Subject: **Application for Section 404 Nationwide 14, Section 401 Water Quality Certification, and Tar-Pamlico Riparian Buffer Authorization** for the construction of US 301 Bypass Improvements between NC 43/48 (Benvenue Road) to SR 1836 (May Drive) in Nash County. TIP No. U-3330. Debit $570 from WBS 36596.1.2.

The North Carolina Department of Transportation (NCDOT) proposes to widen the US 301 Bypass in Rocky Mount from Benvenue Road to May Drive in Nash County, NC.

The purpose of this letter is to request approval for a Section 404 Nationwide Permit No. 14, Section 401 Water Quality Certification, and Riparian Buffer Authorization. In addition to this cover letter, this application package includes the following for U-3330: stormwater management plan, permit drawings, utility drawings, roadway plans, DMS acceptance letter and 4B/4C merger meeting minutes.

Plan Sheet 7 – 42" Pipe outfall and large wetlands

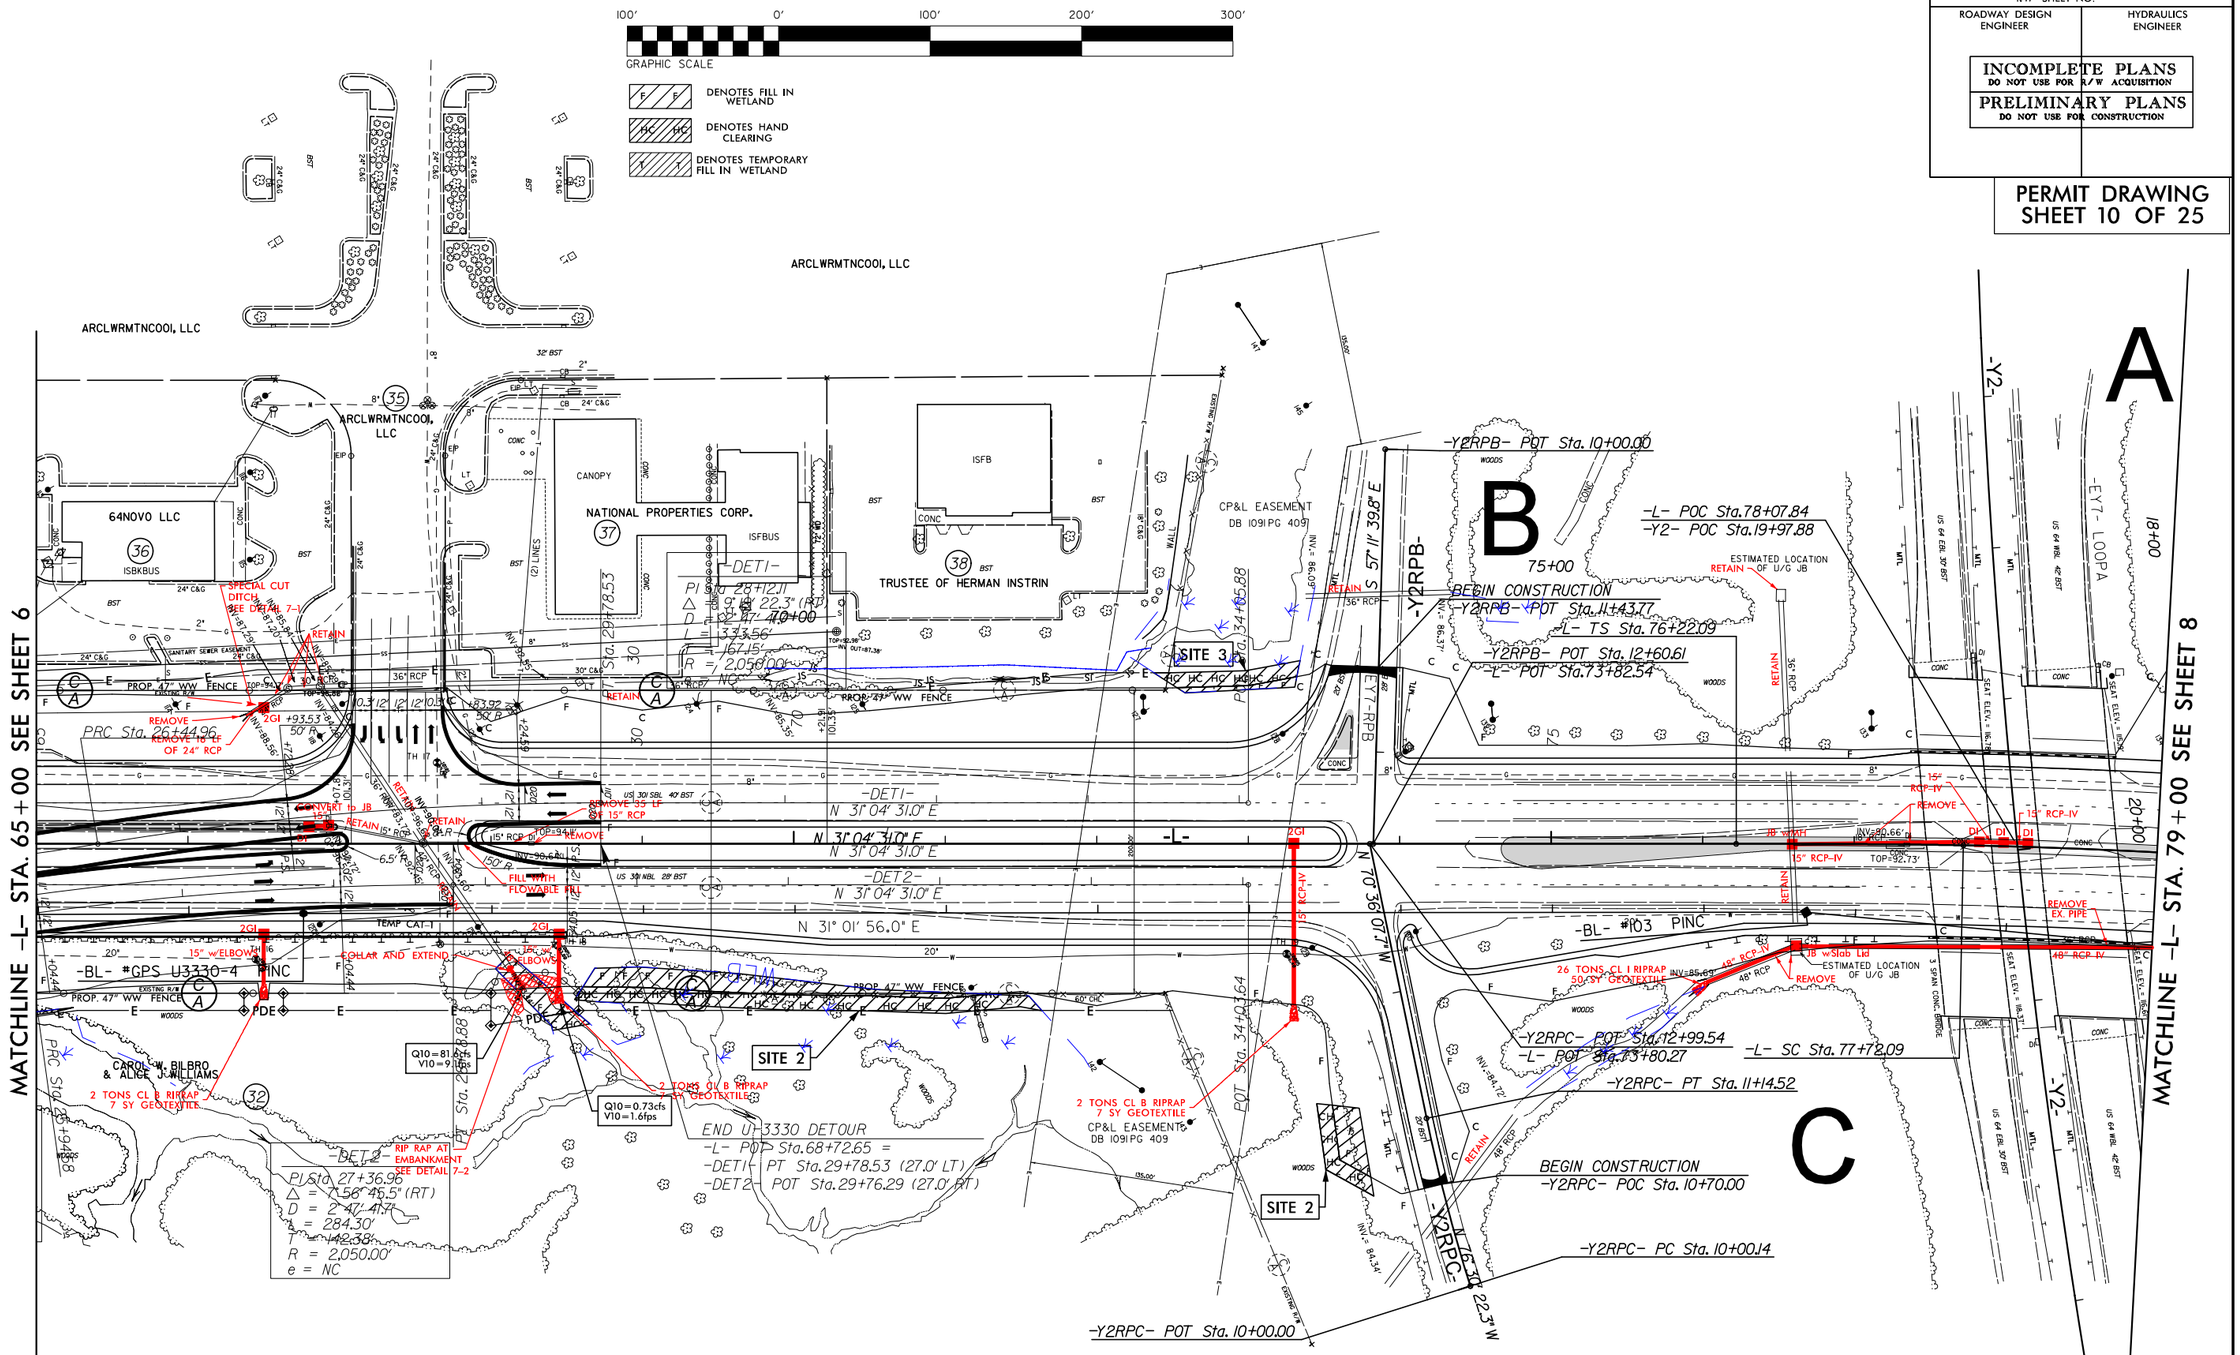
- Make sure that impacts are accounted for when going outside control of access with regards to easements.
- Change the PSH to rock slash pad due to the inaccessible location of outlet of pipe. This is for shoulder berm gutter outlet, behind the guardrail.

Plan Sheet 10 – Box Culvert and cross pipe on Y line

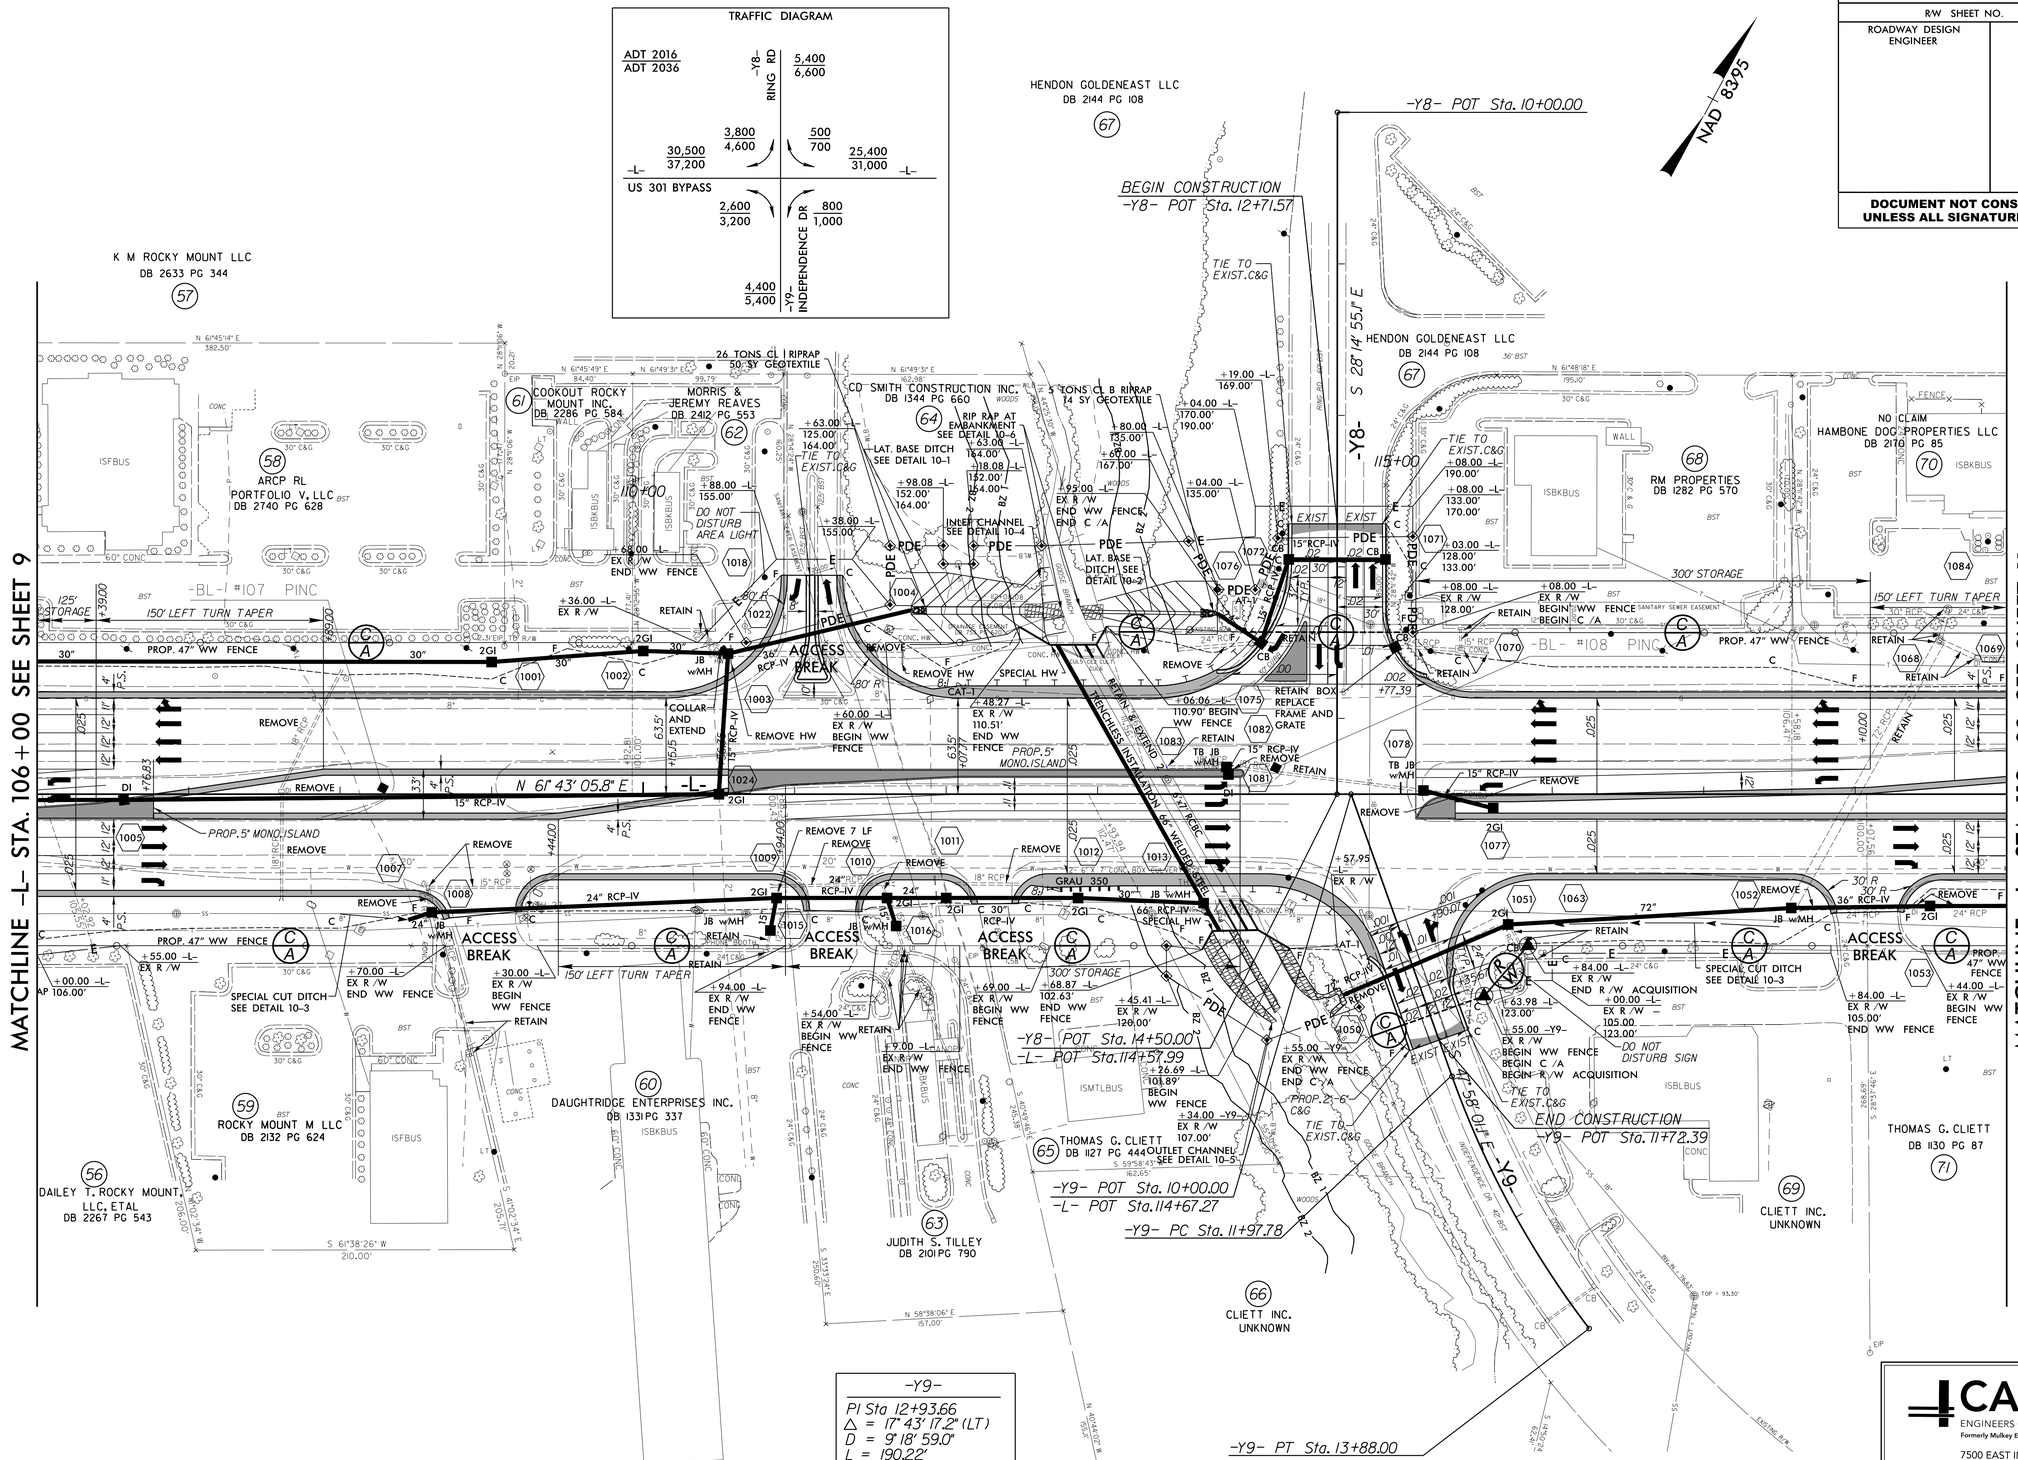
- Make sure ditches have stream bank stabilization when entering streams.
- Change the PSH to a rock splash pad as the contours don't look flat in this area. Check to make sure the velocities are diffused before entering the buffers.
